PUBLIC COMMENT

CSU Wilson Tank Major Modification
6560 Alabaster Way
DEPN-23-0157

Figure 1 photograph. The top of the tank is well above the roof line of the home (marked with red line).

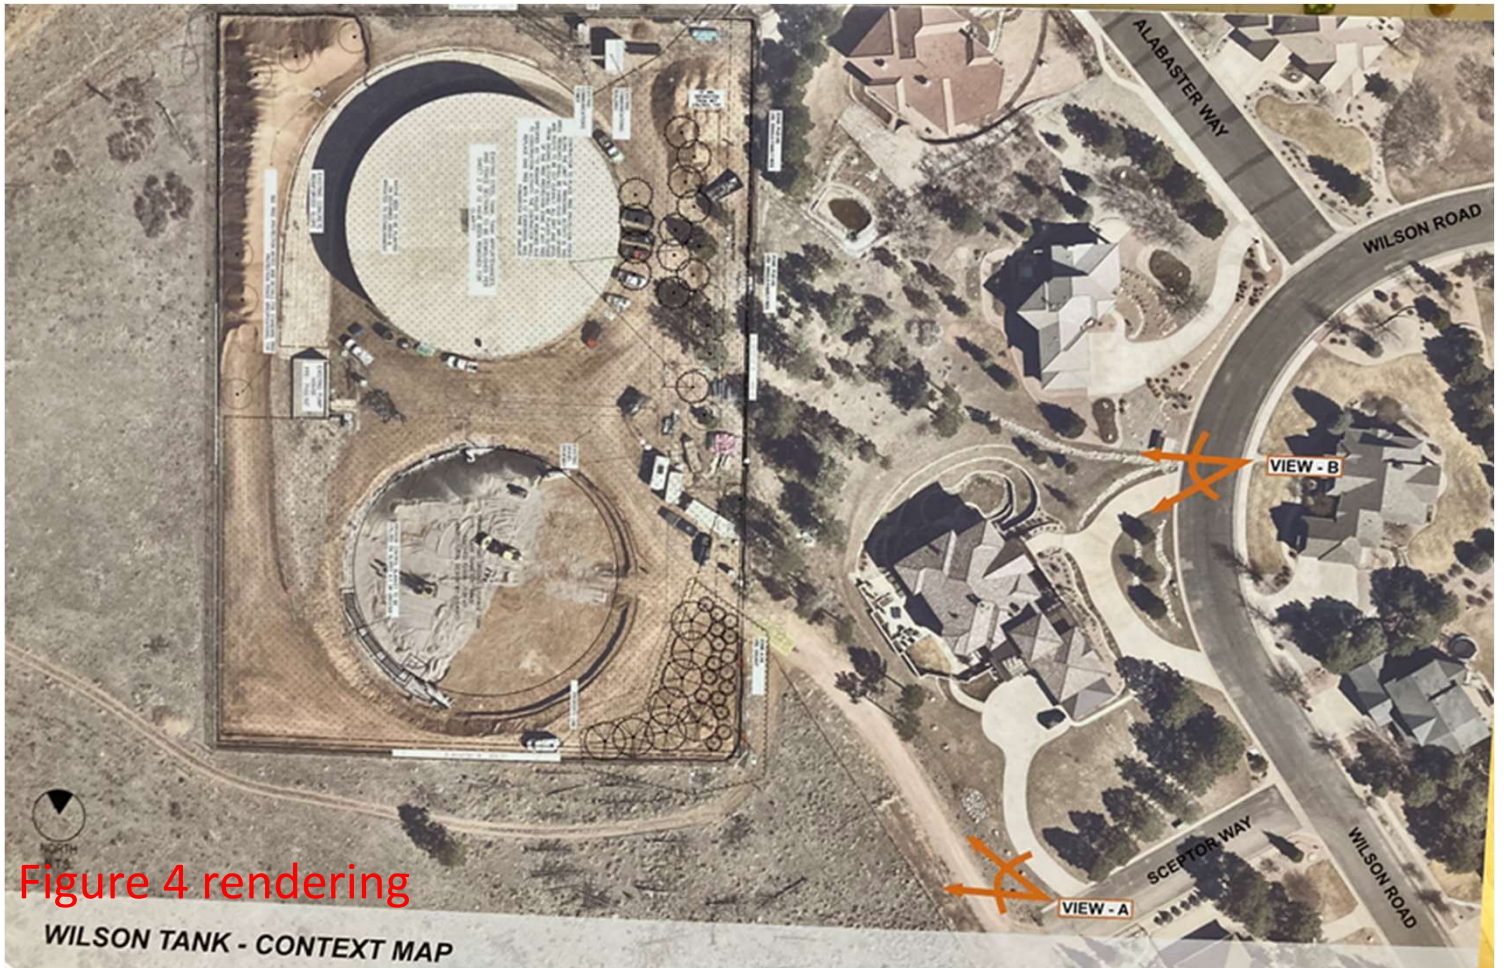
- At 60 feet, the tank towers over neighboring houses, is visible from miles across the city, and is both an embarrassment for our city as a whole and a serious blight on our neighborhood. Frankly, it looks like a UFO landed in our neighbor's yard. **Please see Figure 1 in the attached pdf to see how the massive structure looks from the street.**

Looking at Figures 1 and 2, the renderings show the tank at the originally specified 40 foot height, not at the 60 foot height at which it has been built. You can clearly see this by comparing the roof line of the house to the height of the tank- in the photograph the tank towers over the house and in the rendering the tank is much shorter than the house. As the renderings show, the 40 foot tank can be hidden by trees and paint and blends reasonably into the background, while the 60 foot tank towers over the house and neighborhood.

Figure 1 – Elevation of Tank Height (Page 12, AR DP 21-00526)

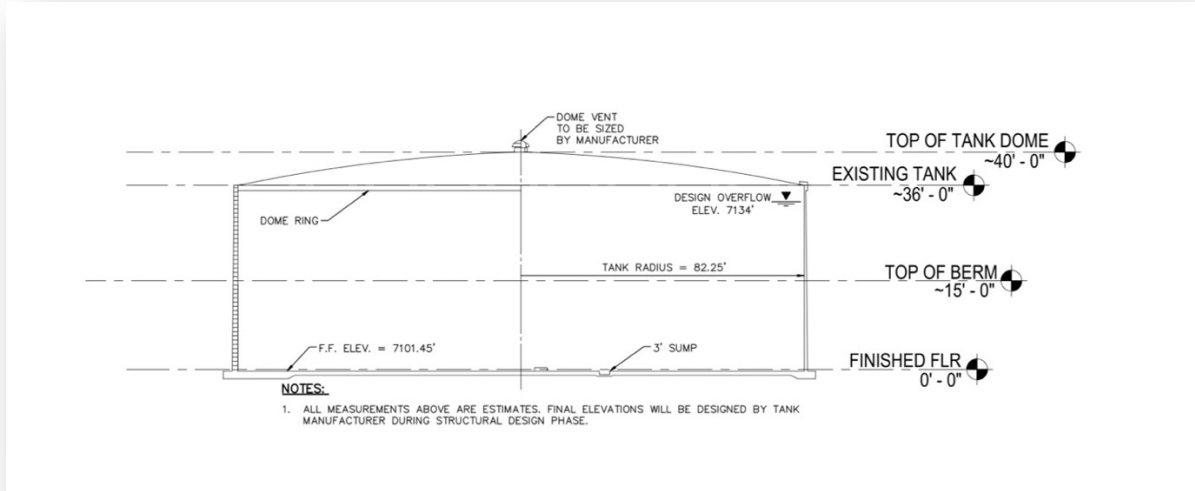
Correspondences and other documents on record for AR DP 21-00526 refer to minimizing the height of the replacement tank to be similar to the existing tank. The geological report lists the height of the existing tank as 32.5 feet (measured). An elevation (see Figure 1) from the approved plan has the replacement tank's height as 36-foot walls with a 4-foot dome for a total of 40 feet. Additionally, the approved engineering drawings has a maximum height "per code" of 45 feet (see Figure 2). The proposed modification (DEPN-23-0157) lists the height as approximately 60 feet. Currently, the tank is under construction and the height of 60 feet is now the as-built height. Depending on one's starting point, the as-built tank is between 48% and 82% higher than plan specifications and expectations. The fact the as-built tank is almost twice the height of the existing tank represents CSU's gross disregard for 1) the surrounding neighborhood and 2) Planning's procedures/processes. We consider constructing the as-built tank at its current height is unconscionable and cannot excuse the misinformation promulgated by CSU and their subcontractors.

The as-built tank is almost twice the height Colorado Springs Utilities (CSU) and Kimley Horn (KH) told the geological companies it was planned to be. Whether this is of consequence should be left to the experts; however, it is not being resubmitted as CSU is not following the required procedures. Other critical oversites like this one may exist since CSU indicated to all parties up through the final decision, that the tank replacement height was to be similar to the existing one.

Requested Action: Require CSU to adhere to the 45 feet maximum height as defined at the time of the Development Plan review.

Figure 3 – Development Plan Approval Process §7.5.515.C

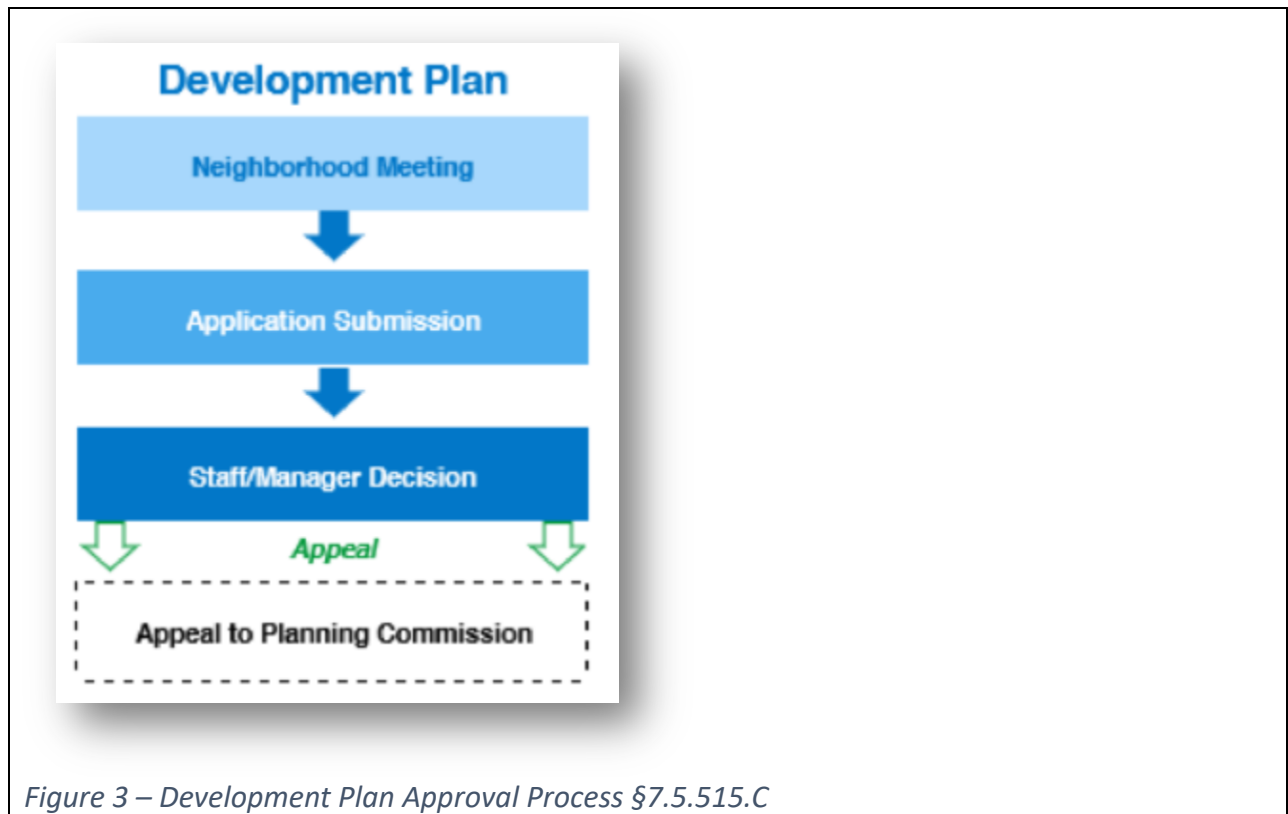
The required action, to submit for City Planning review, was not taken in November 2022 when the plans containing the structural detail were completed nor when later submitted to Pikes Peak Regional Building Department for a permit. The major height change was known at that time. As recently as mid-June 2023 (a mere 6 weeks ago), a CSU public relations representative and a KH representatives continued to say the height of the tank would be similar to the existing one. This mindset changed after the tank walls and roof outline became apparent when the scaffolding was erected and, most

Requested Actions: Revoke approval and require CSU to follow UDC procedures outlined in §7.5.516.B.2 and resubmit the entire plan for the required review.
